This paper describes the service experience gained from G60-, G70-, G80-, and G95-GI engine types.

Service experience for Everllence B&W ME-GI two-stroke engines

Fig. 1: Chain pipes for methane supply and purge in Mk. 1 (a) have been simplified in the Mk. 2 design (b) with only one pipe for both supply and purge operations

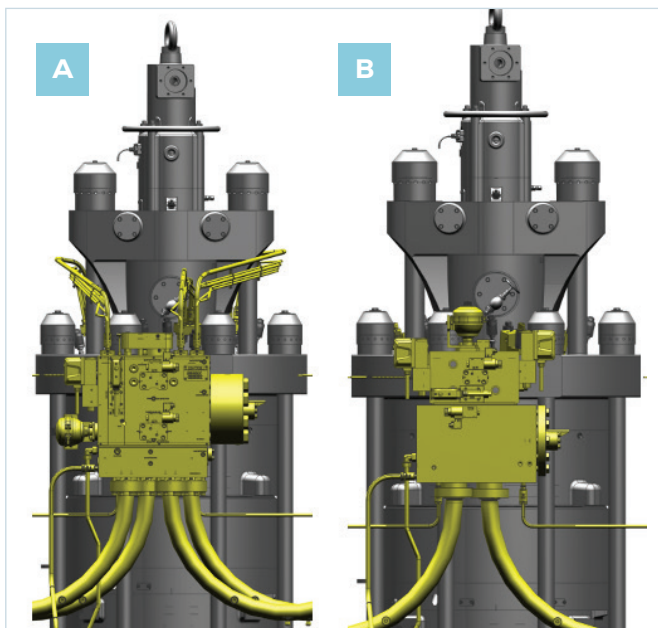
Fig. 1 shows the simplification of the chain pipes for methane supply and purge in the Mk. 2 design, so that the supply and purge use the same pipe.

Fig. 2: Simplification of the gas block from Mk. 1 to Mk. 2

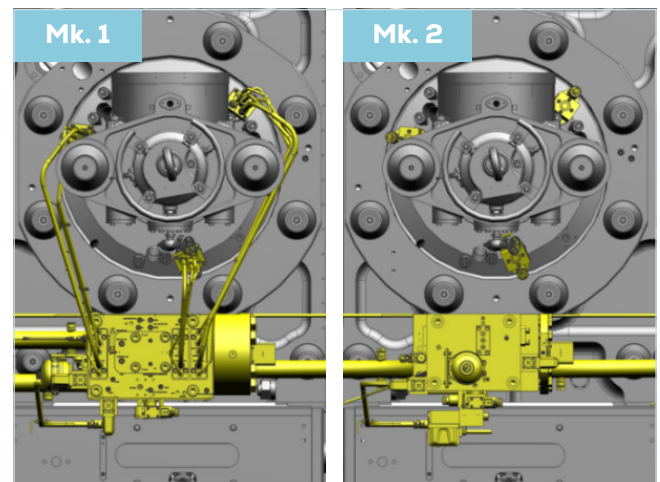
Fig. 2 illustrates the simplification of the gas block from Mk. 1 to Mk. 2 design.

Fig. 4: Gas non-return valve replaced by a fixed orifice

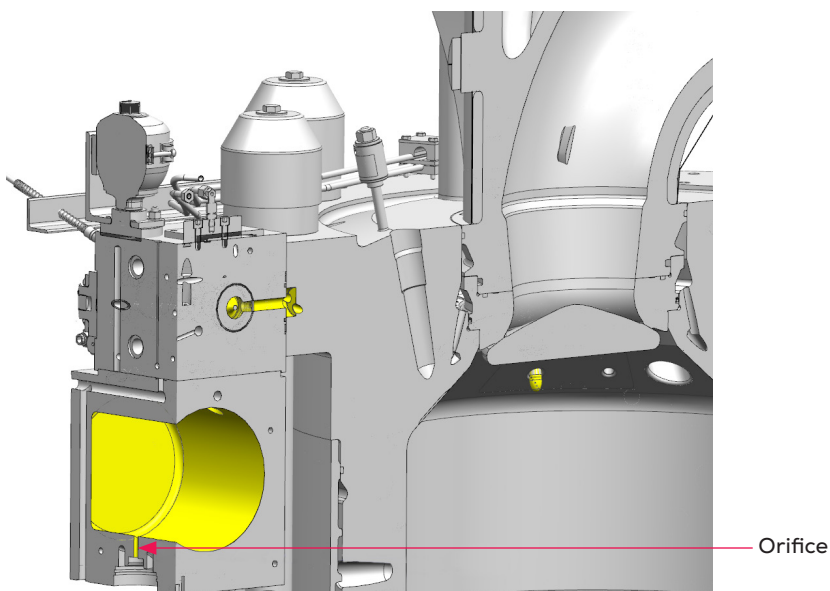
In the Mk. 2 design shown in Fig. 4, the methane non-return valve has been replaced with a fixed orifice, which has eliminated the need for gas pressure curve fitting, and issues with sticking or damaged non-return valves.

Fig. 10: Pilot oil and fuel booster injection valve (PBIV) top cover leakage

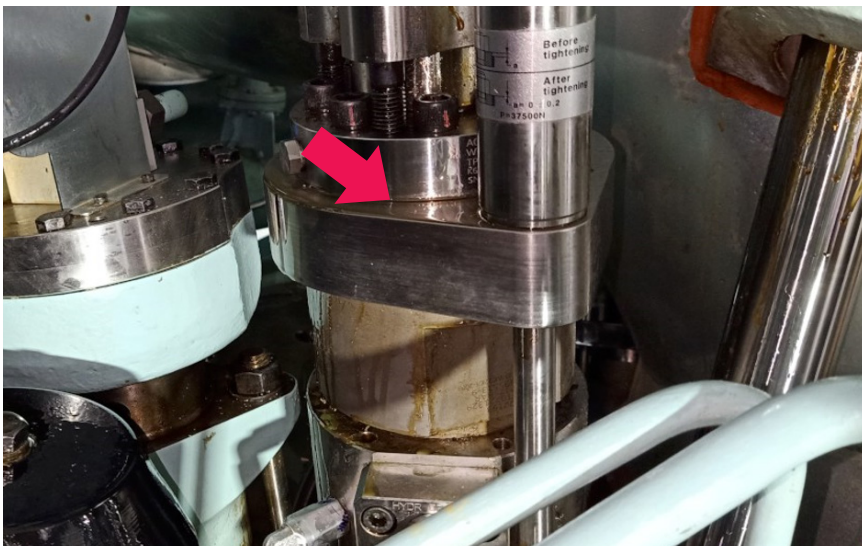
The top cover of the pilot booster injection valve (PBIV) has been observed leaking hydraulic oil from the top cover (Fig. 10), sometimes after only a few hundred running hours.

Fig. 11: Viton O-ring becomes too soft and disintegrates

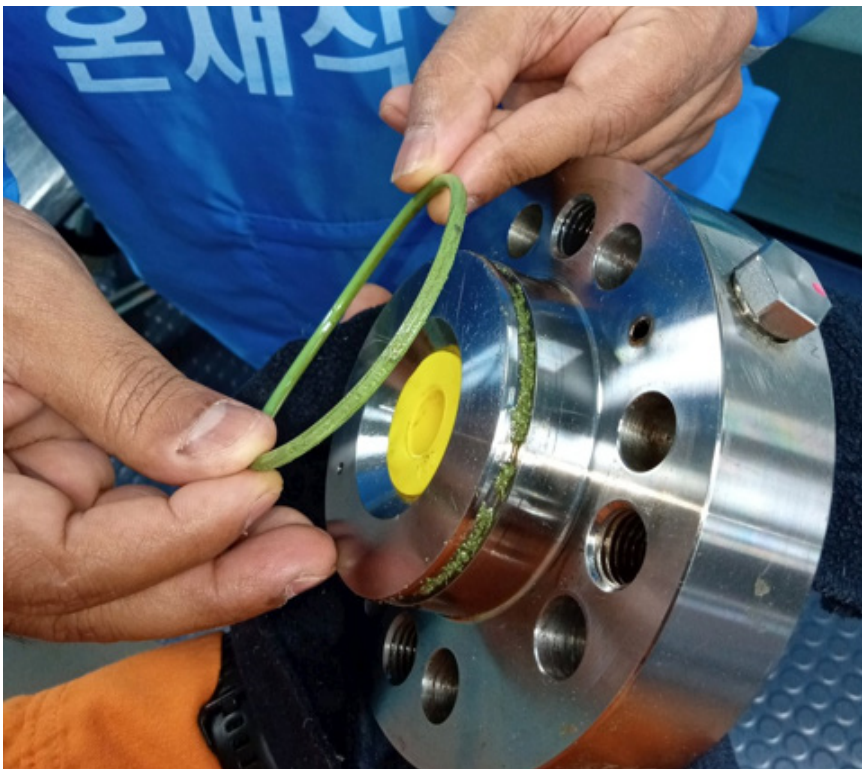
Leakage has been observed in most types of PBIV across various engine types. The root cause has been identified as the Viton O-ring in the top cover (Fig. 11), which becomes too soft and eventually disintegrates.

Fig. 12: The PU seal (b) has replaced the Viton O-ring (a), which caused leakage from the top cover

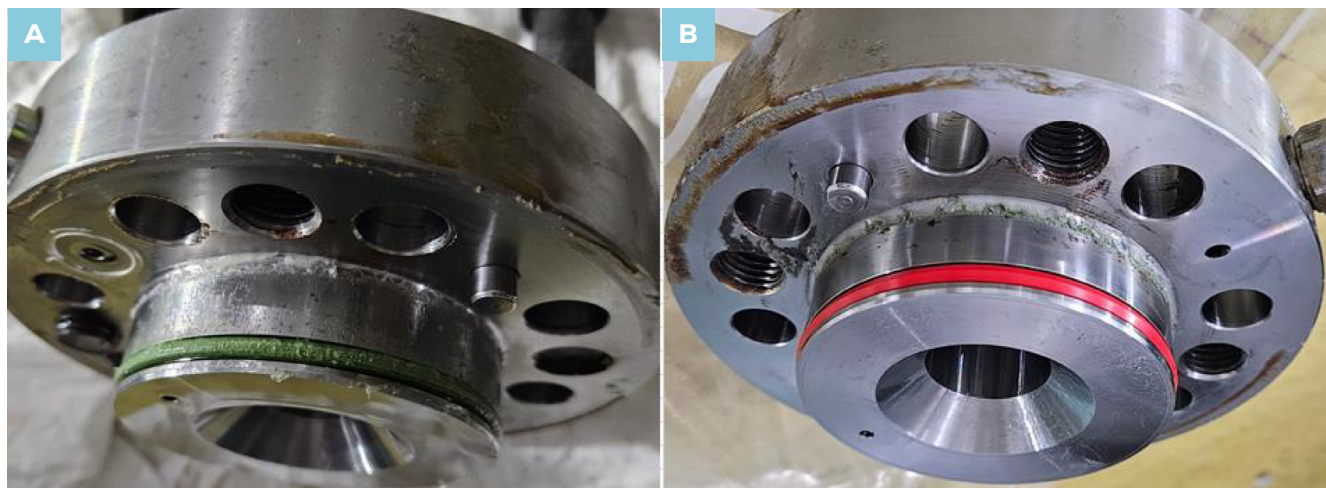
The solution has been to replace the Viton O-ring shown in Fig. 12a with the PU seal shown in Fig. 12b, which is equally easy to install as the original Viton O-ring.

The new PU seal has resolved the leakage issue on the top cover of PBIV.

Fig. 16: Belleville spring could drop down and get wedged between the WVFC and the gas block

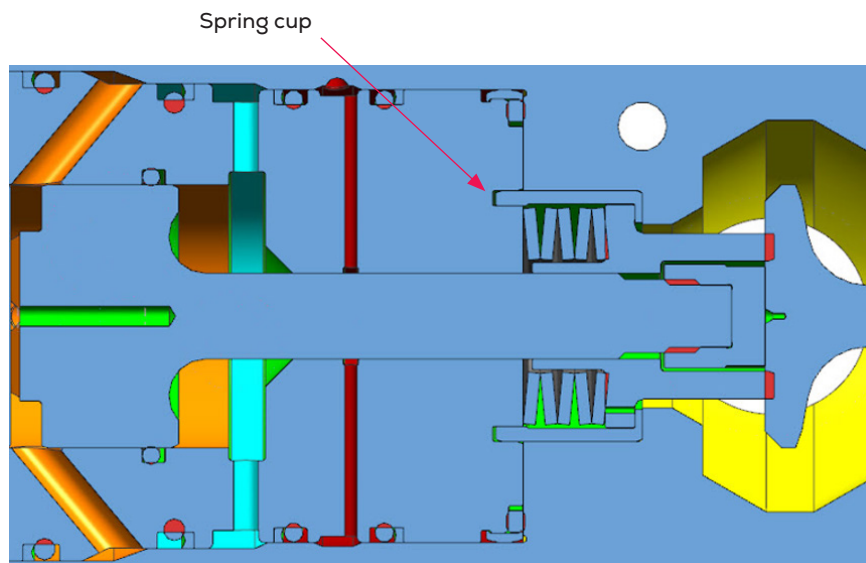
As shown in Fig. 15, when installing the first version of the WVFC, a Belleville spring could drop down and get wedged between the WVFC and the gas block.

Fig. 17: Schematic illustration of gas block damage caused by the Belleville spring dropping down during installation of the original WVFC design

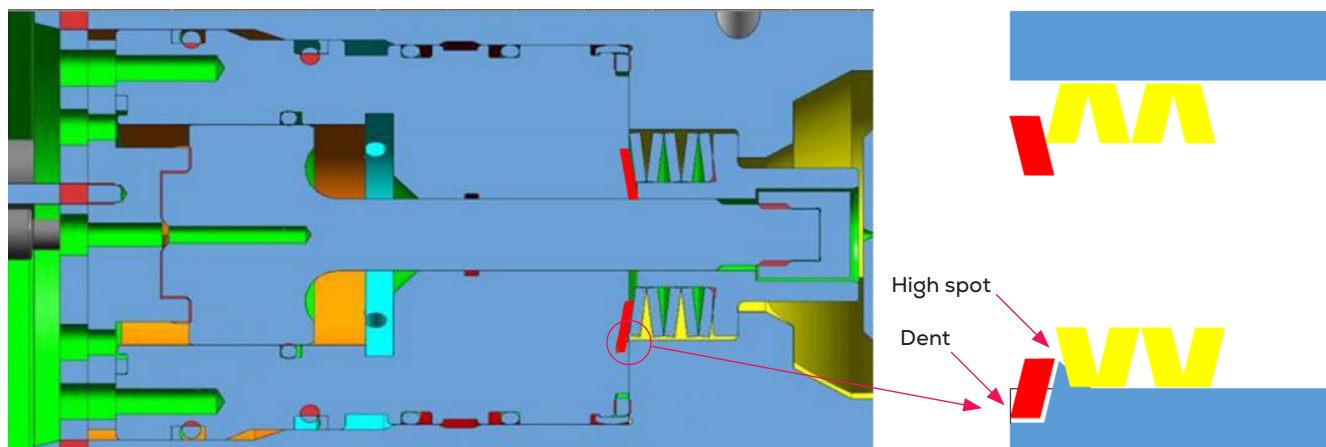
This design change has eliminated the risk of springs dropping down and the associated risk of gas block damage during WVFC assembly. Fig. 17 shows a schematic illustration of gas block damage because the Belleville spring had dropped down during the installation of the original WVFC design.

Fig. 18: Comparison of a) the original and b) the new WVFC design with a spring cup

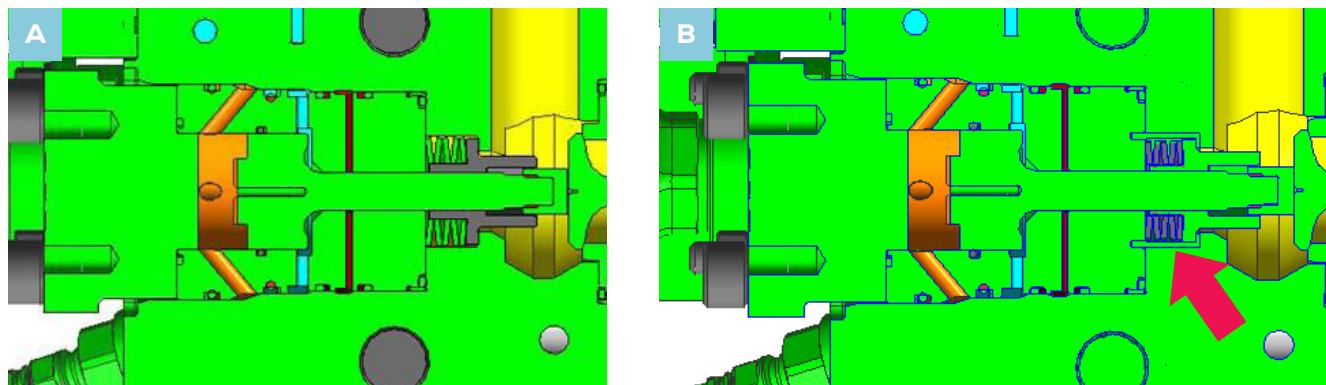
Fig. 18 compares the original and the new WVFC design,

which has been updated with a spring cup to prevent damage to the gas block.

Updated instructions have been issued to guide the crew when mounting a WVFC of the original design.

Fig. 19: O-rings deteriorating rapidly, leading to internal sealing oil leakage

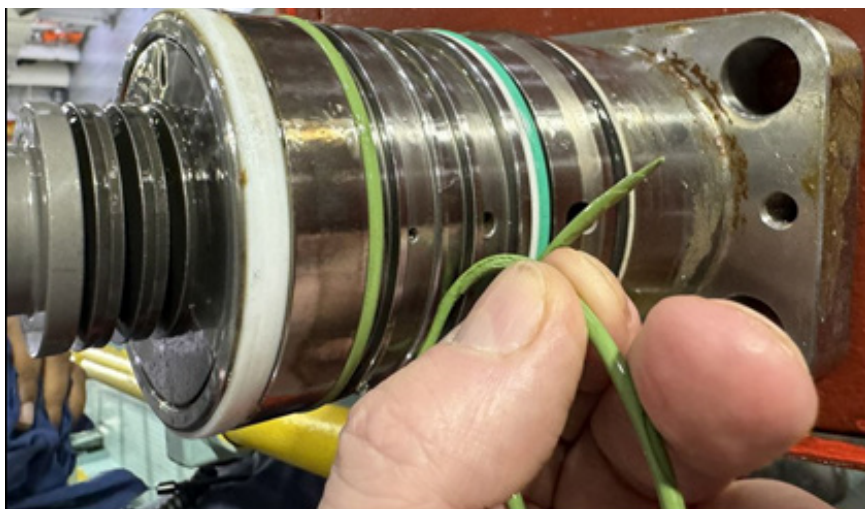
In the WVFC, O-rings kept breaking, leaking sealing oil internally to either the outer pipe or sealing oil return/drain lines. As Fig. 19 shows, one reason was a rapid deterioration of O-rings.

Fig. 20: Updated design with different O-rings and new backup rings

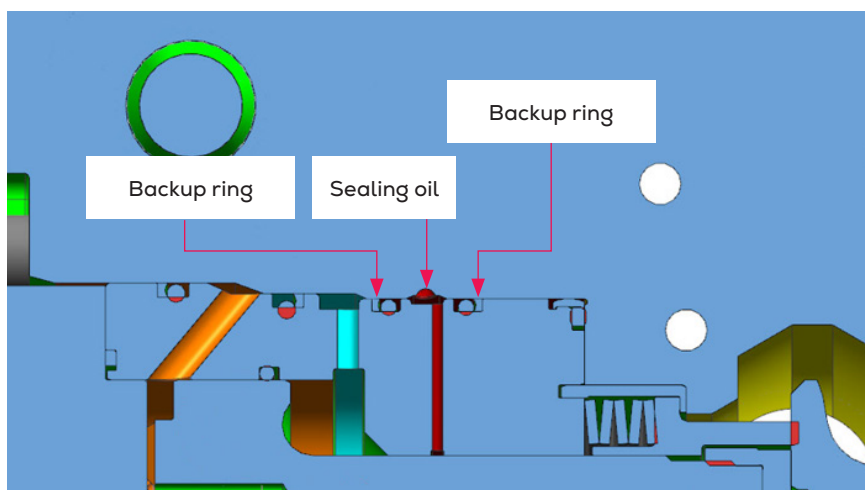
Fig. 20 shows the design solution, which resolved the leakage issue from the WVFC.

The solution has been to change the O-ring material and to introduce an uncut backup ring design. To mount the new uncut backup ring, an expander tool must be used.

Fig. 22: The backup ring and the oblique cut damaging the O-ring

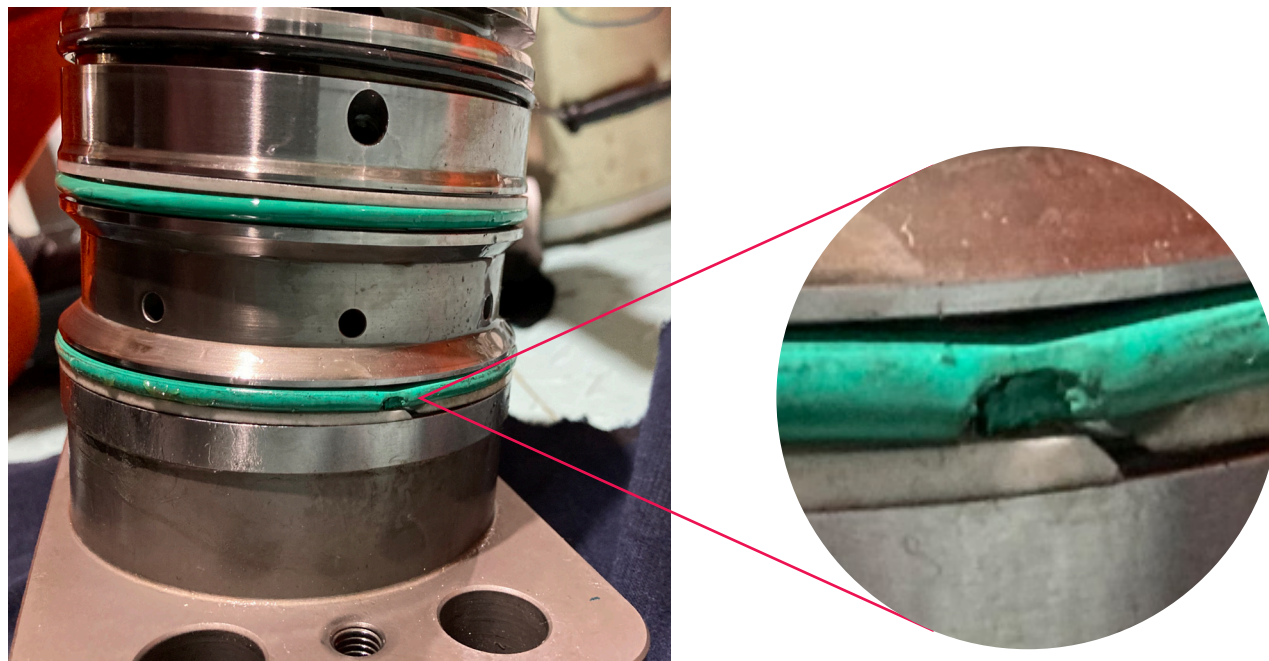
The leakage would get progressively worse until it affected the operation of the window valve, eventually causing dual-fuel shutdown and switch to liquid fuel oil mode. The window valve had a backup ring with an oblique cut that could

damage the O-ring, and lead to its rupture. Fig. 22 shows the backup ring and the oblique cut damaging the O-ring.

The solution has been to introduce an uncut backup ring design. Also in this case, an

Fig. 23: Eight positions where the sealing design has been updated for the WVFC and window valve

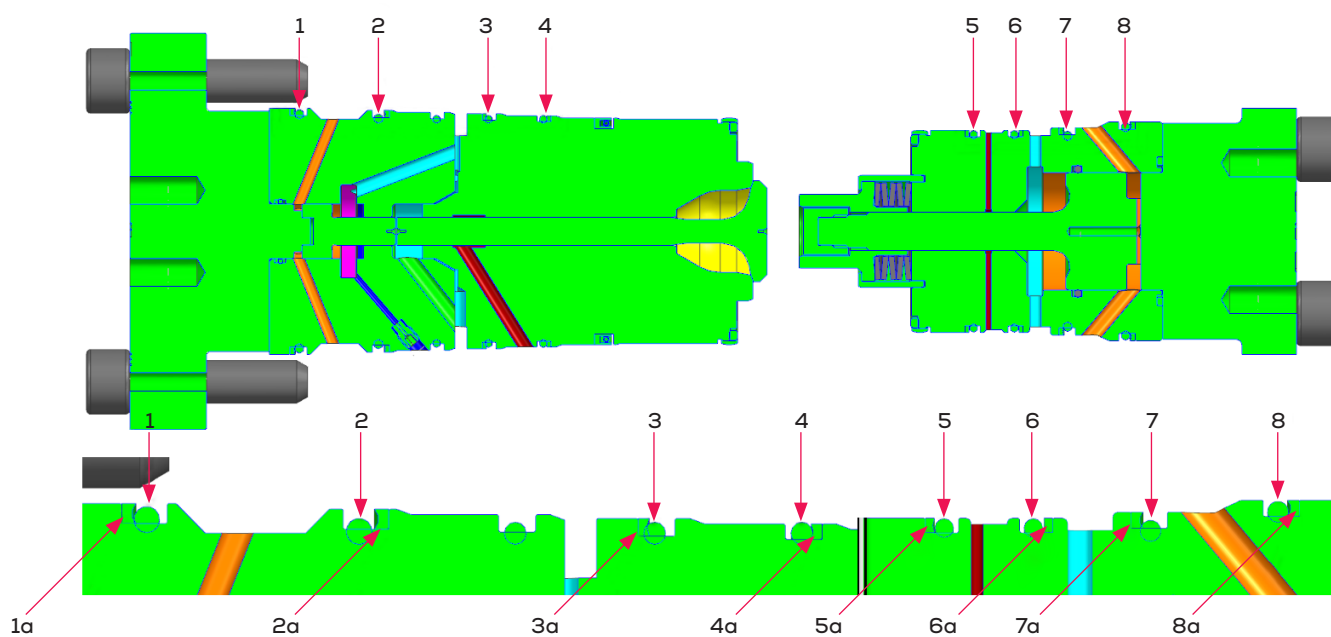
expander tool must be used to mount the new backup ring. Fig. 23 shows all eight positions where the sealing design has been updated for the WVFC and window valve in new engine production and engines in service.

Fig. 25: a) Original long nozzle, b) temporary short nozzle, and c) extra-short nozzle

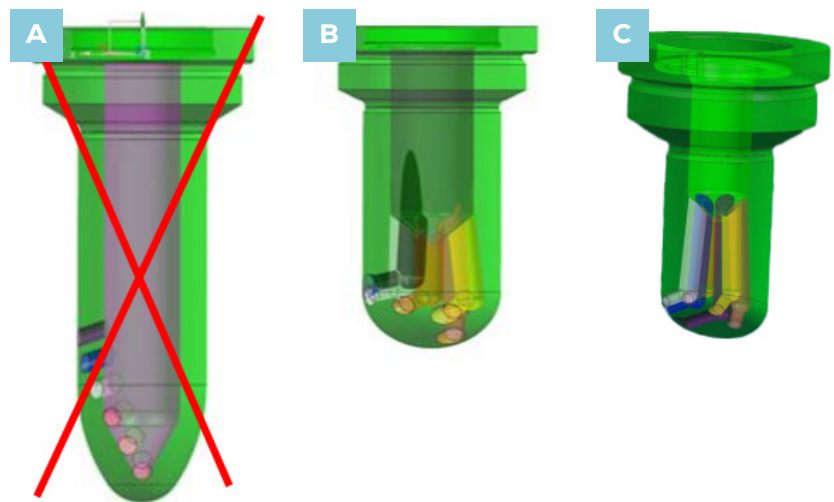
The original long design of gas nozzles suffers from hot corrosion. Fig. 24 shows an example of heavily hot-corroded long nozzles from a G60ME-C10.5-GI Mk. 2 engine.

To achieve an optimal nozzle tip temperature and prevent hot corrosion while avoiding nozzle clogging, the shorter nozzle designs in Fig. 25 have been investigated. The temperature of the nozzle tip is an important parameter in avoiding nozzle hot corrosion and clogging.

The extra-short nozzle design in Fig. 25 is running without clogging and with acceptable levels of hot corrosion for 8,000 hours in G70ME-C9.5 engines. However, clogging remains an issue for G70ME-C10.5 engines, where nozzles that are 5 mm longer will be tested as a potential solution.

Fig. 29: Nozzles with larger pilot oil injection holes and an increased number of injection holes

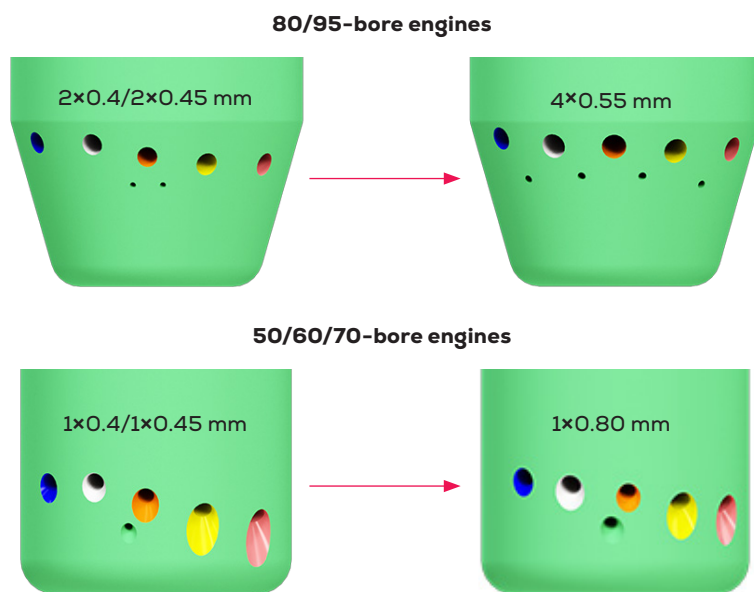
Presently, a PIV nozzle in H13 tool steel is being service-tested, and the crack issue is under control. However, this nozzle suffers from clogging of the small pilot oil injector holes. Fig. 29 shows the test setup for testing larger pilot oil injection holes and an increased number of injection holes to reduce the frequency of clogging.

For 80- and 95-bore engines, the nozzle tested will have four pilot oil injection holes, each with a 0.55 mm diameter, instead of two holes with 0.4 mm diameter for 80-bore engines and two with 0.45 mm diameter for 95-bore engines. For 50-, 60- and 70-bore engines, the nozzle being tested will have one pilot injection hole with a diameter of 0.8 mm, replacing the previous configuration of one hole with 0.4 mm diameter for 50-bore engines and one with 0.45 mm diameter for 60 and 70 bore engines, respectively. However, the test program has been delayed due to the need for amendments to the IMO technical file before testing can commence.

As a short-term countermeasure, we recommend deactivating the reduced lift (RELI) function and introducing corresponding modifications to the system parameter file (SPAF). This will reduce the risk of clogging; however, it will increase the pilot oil amount somewhat.
